Main Street Advisory Board
Agenda – October 5, 2023, 5:00 p.m.

STAFF REPORT

CASE NUMBER: COA-0120-2023

CASE NUMBER: COA-0138-2023
APPLICANT: Madison Holland
REQUEST: Extend parapet wall, paint, new awnings, light fixture
LOCATION: 904 Jernigan Street; Parcel No. 0P0040 018000

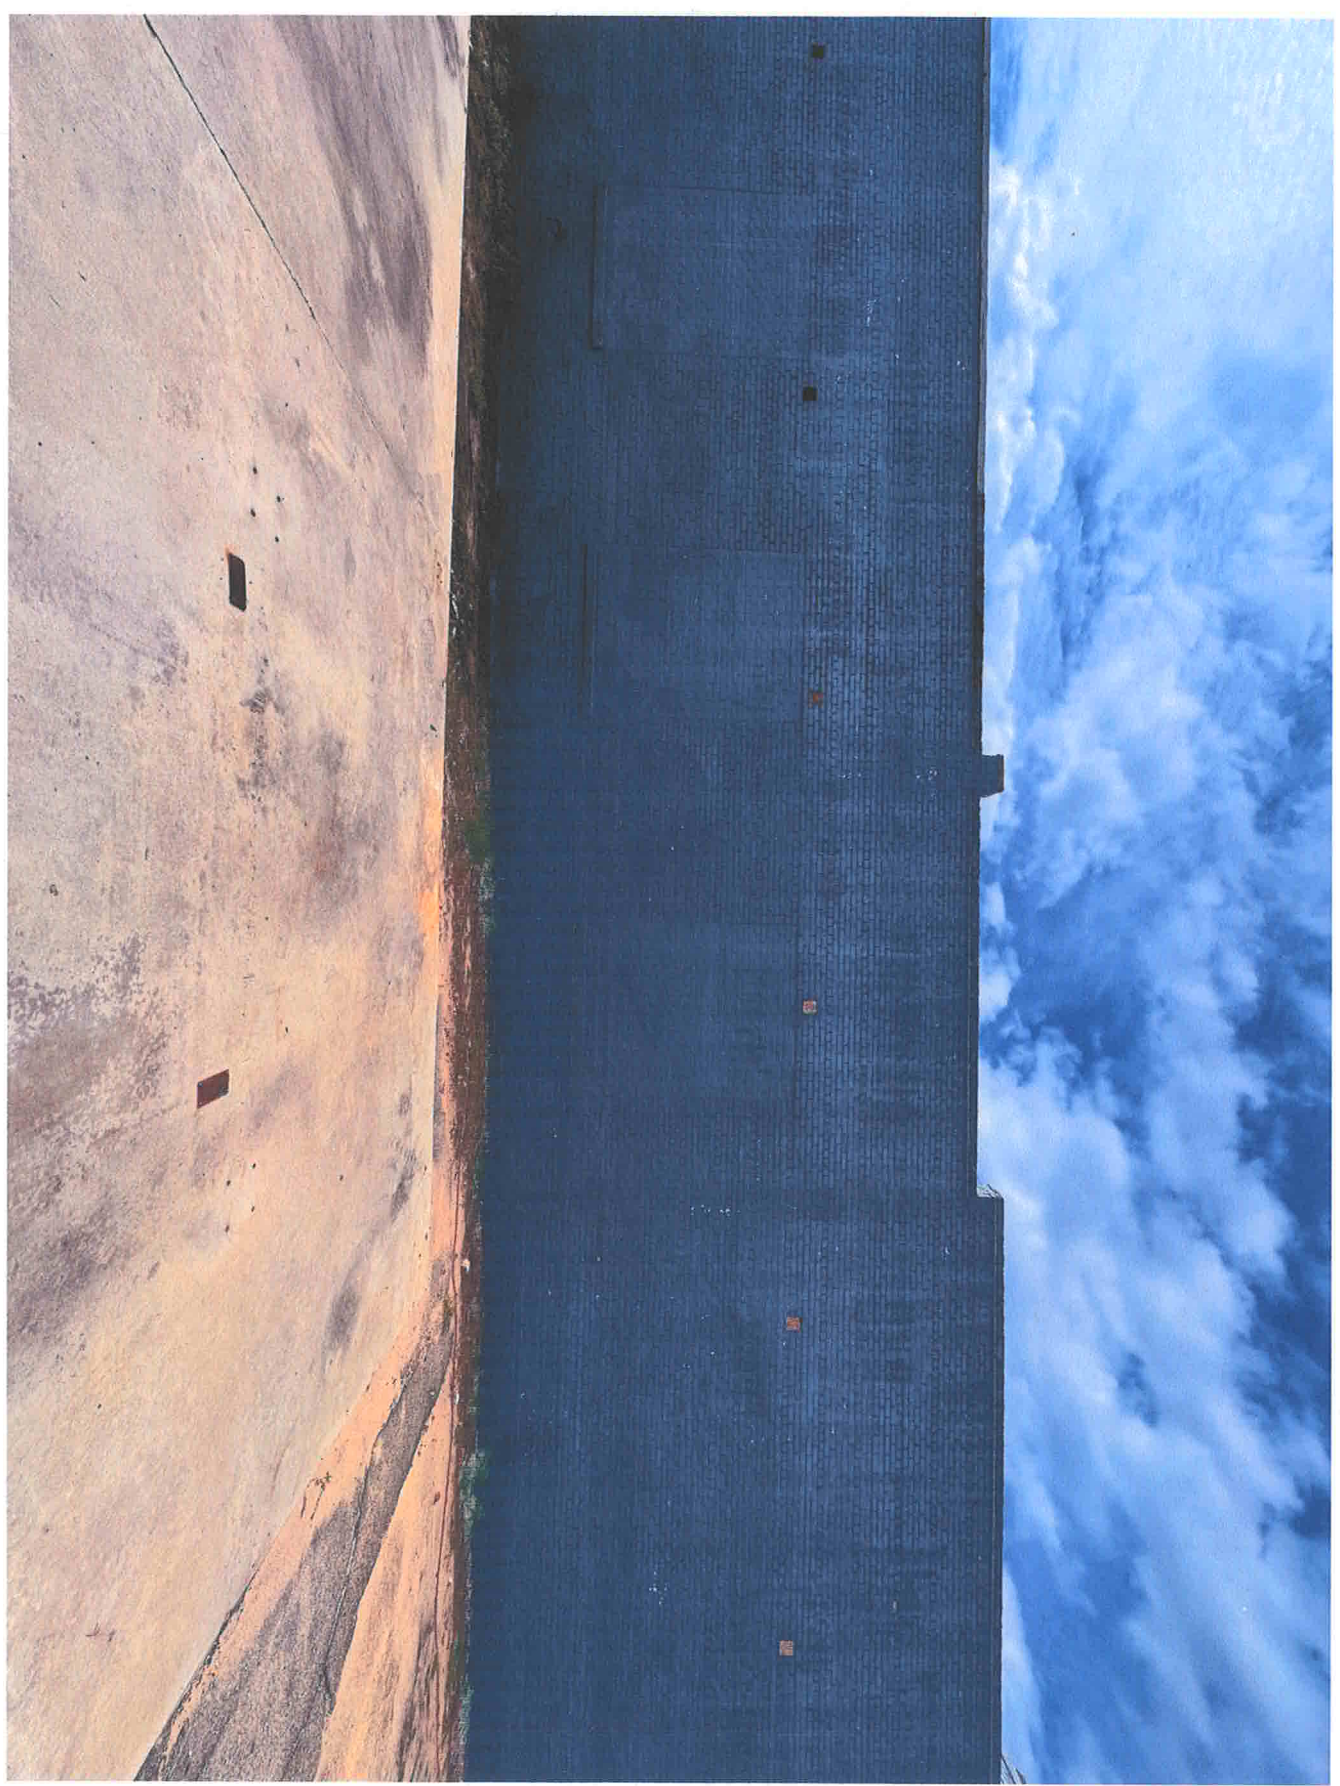
APPLICANT'S REQUEST: The applicant proposes bricking in the existing window on the side elevation facing the vacant lot adjacent to Commerce Street. The brick will be painted to match the existing painted brick color. The applicant indicates in his application that the cost to infill the window is similar to replacing the broken glass.

STAFF COMMENTS: The proposal is inconsistent with design guidelines which state existing window configuration and dimensions should be maintained, and that infilling windows is a common mistake.

STAFF RECOMMENDATION: Denial.

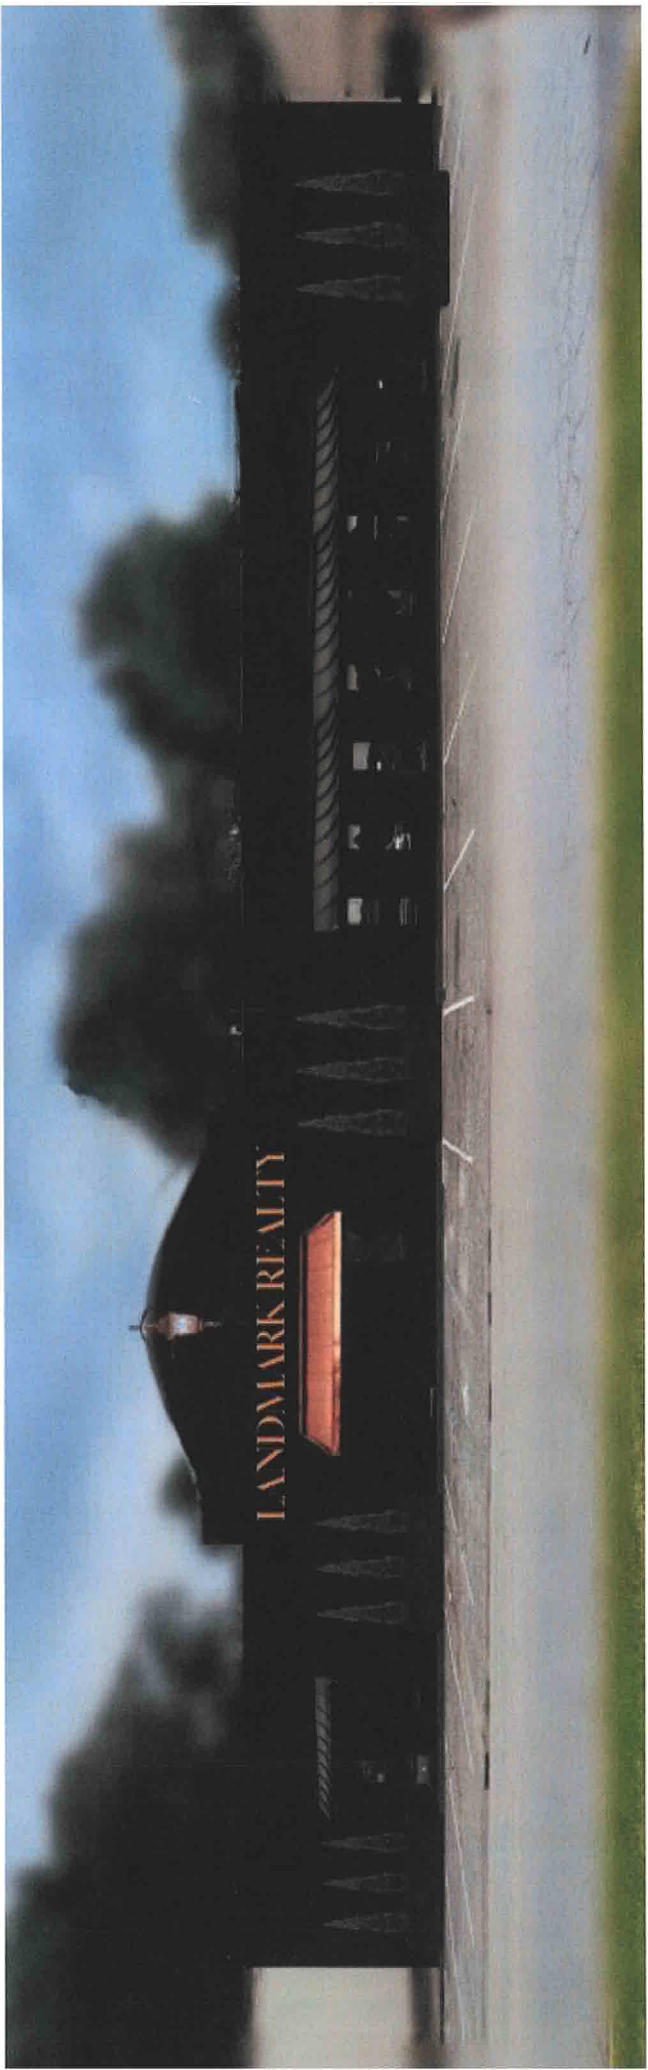
APPLICANT'S REQUEST: The applicant proposes to heighten the parapet wall over the main entrance, paint the exterior, replace existing awnings, and add a lantern. The added parapet wall will be clad in stucco to match the existing building finish. The building will be painted black (specific color not specified). The existing two fabric awnings will be replaced with three metal awnings. Two of the awnings will be black; the center awning will be copper. A large brass lantern will be added in the center of the raised parapet.

STAFF COMMENTS: The original office building was constructed in 1947 and was expanded in about 1990. At the time of expansion or later, the front façade was renovated with stucco siding and vertically oriented windows. Nothing of the original 1947 building appears to remain. The rehabilitation guideline for Roofs suggests that parapets should not be altered. However, in staff's opinion, this building does not exhibit any significant architectural detail which would preclude the proposed modification of the parapet.

Since the building has three separate entrances, the proposed modifications are appropriate to identify the main entrance. The proposed three separate awnings comply with the design guideline for awnings.

STAFF RECOMMENDATION: Approval.

SITE PLAN FOR:
1139 & 1141
PERRY

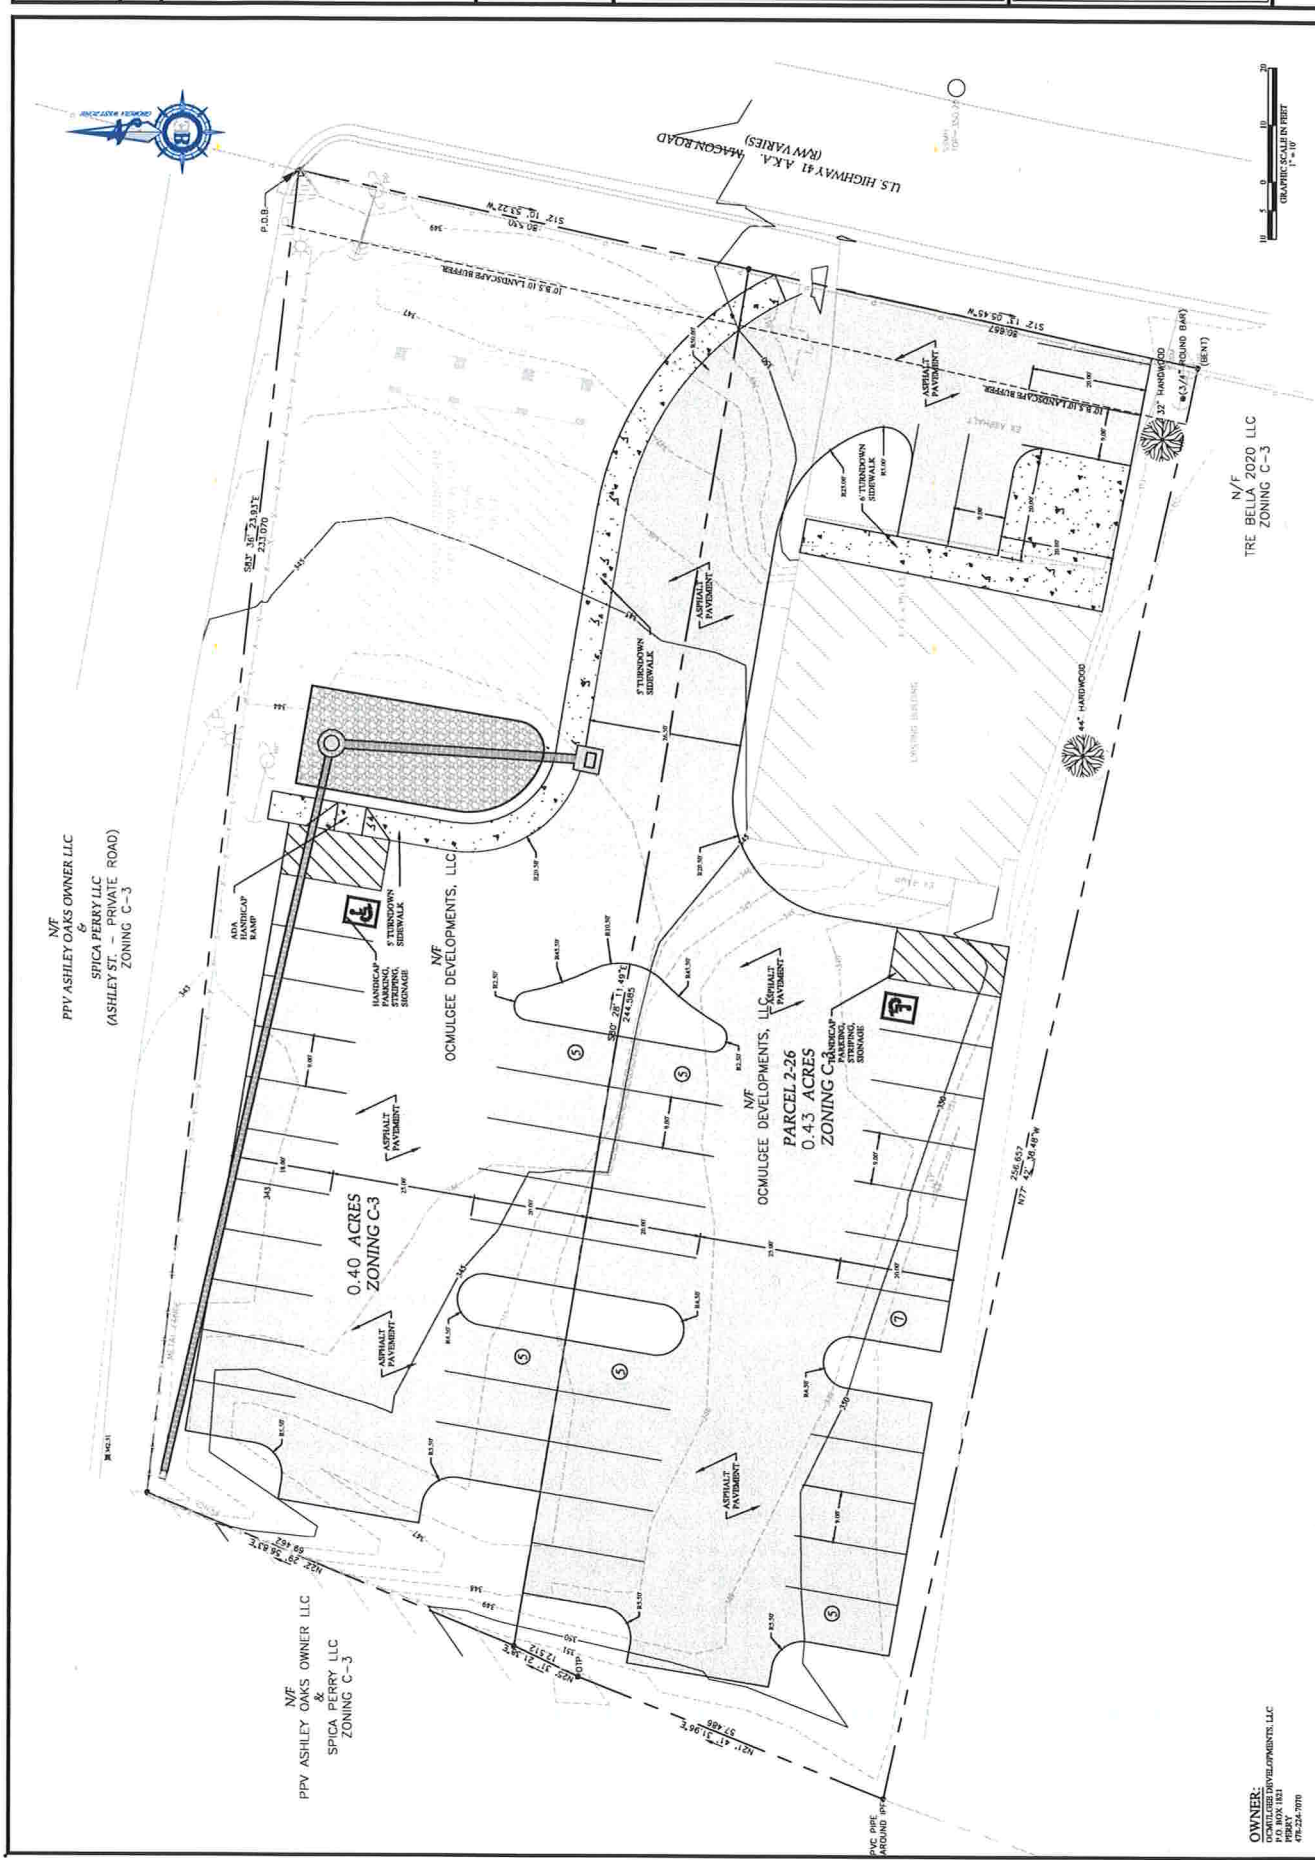
As an expansion of the existing parking lot at 1139 Macon Road, the site must comply with current parking lot standards. Staff will confirm compliance during review of the site construction plans.
